## MOAB PEDESTRIAN ROAD SAFETY ASSESSMENT

### MAIN STREET FROM EMMA BOULEVARD TO 4TH EAST

## MOAB PEDESTRIAN ROAD SAFETY ASSESSMENT

June 2024

**Photograph 2 – Missing Sidewalk**

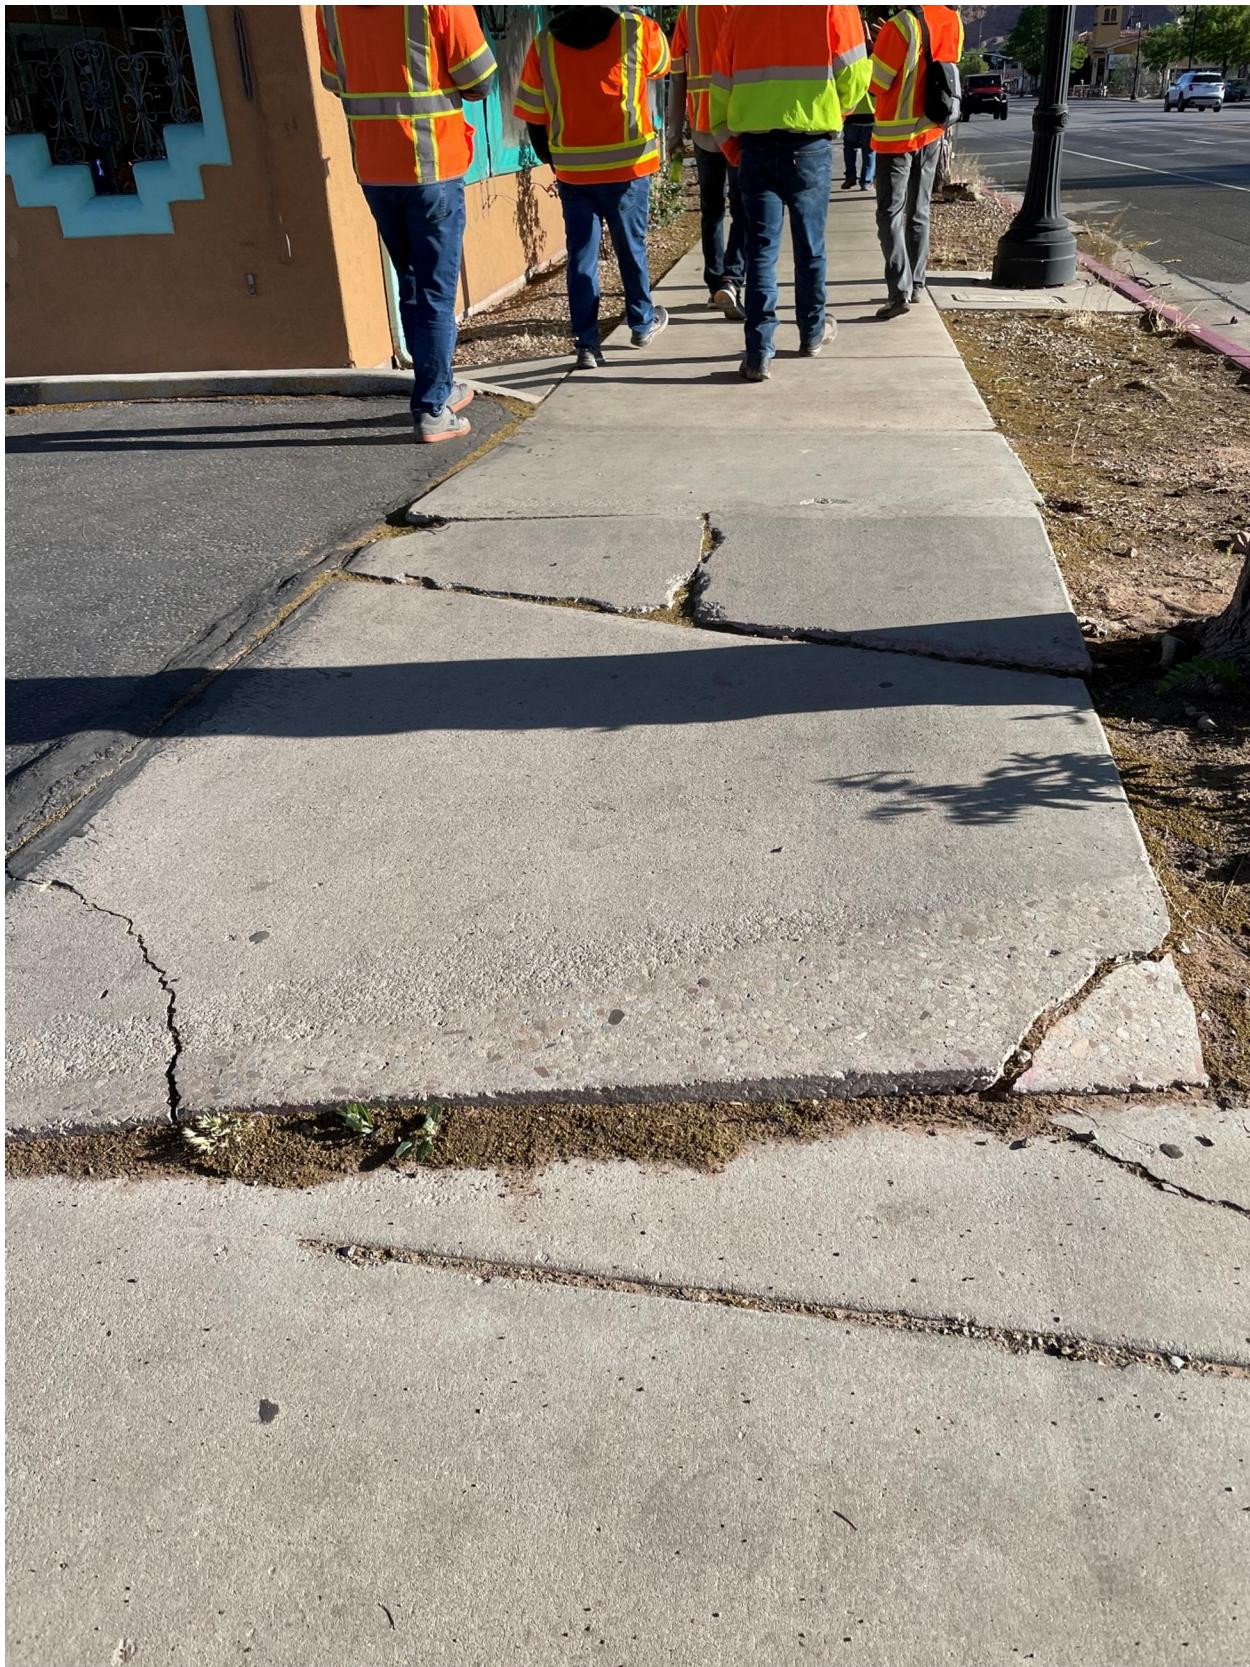
Along Main Street several sections of sidewalk were observed to be uneven, damaged, or missing. The goal to complete the sidewalk network would be ideal for all active transportation users. Specific locations noted to have sidewalk damage include surrounding the Walker Stores, the Moab Information Center, Fiesta Mexican driveway, and areas near the City Market. See **Photograph 2** and **Photograph 3**.

***Priority 1: Repair locations with broken or uneven sidewalks (Moab)***

***Priority 1: Repair sidewalks where tree roots have upheaved or broken in sections (Moab)***

***Priority 2: Consider Safe Sidewalks funding to complete the sidewalk network where gaps are present. (Safe Sidewalk funding can only be used to construct new sidewalks) (Moab)***

***Priority 3: Investigate less disruptive tree species to install near the sidewalk and gutter (Moab)***

**Photograph 9 – Segment with Multiple Access Drives**

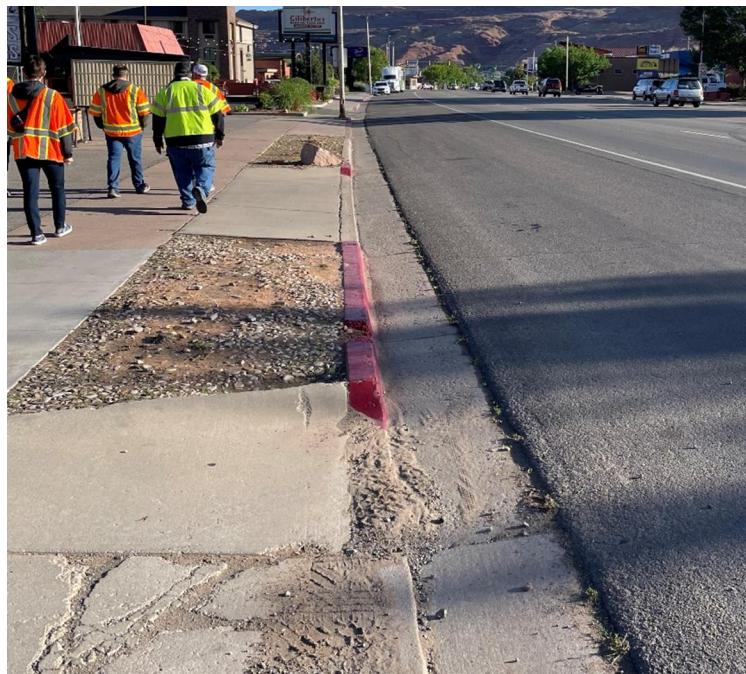
Along Main Street there are multiple minor streets, access driveways, and other intersections with the corridor. Most access driveways are full movement accesses where vehicles turning left onto Main Street are vulnerable to opposing vehicles and often experience delays. Vehicles hoping to turn left onto Main Street also experience conflicts with groups of pedestrians as they cross access driveways. See **Photograph 9**.

***Priority 3: Evaluate locations for median installation along the entire corridor to reduce left turn conflicts (UDOT/Moab)***
